TMS370 v1.7 ERRATA SHEET

Figure 1.

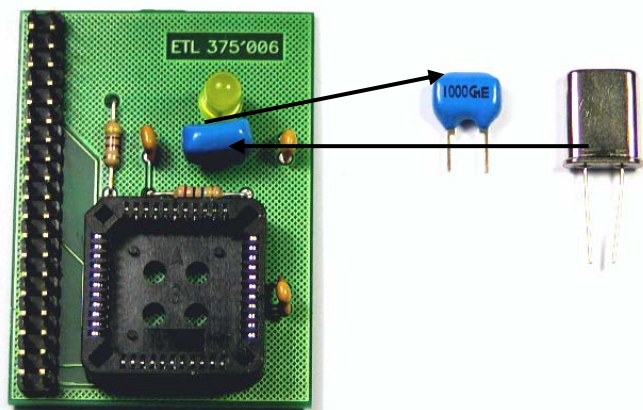
TMS375C006, TMS370C702 time instability error fix:

- Replace ceramic resonator to quartz crystal resonator 1 Mhz to fix frequency instability
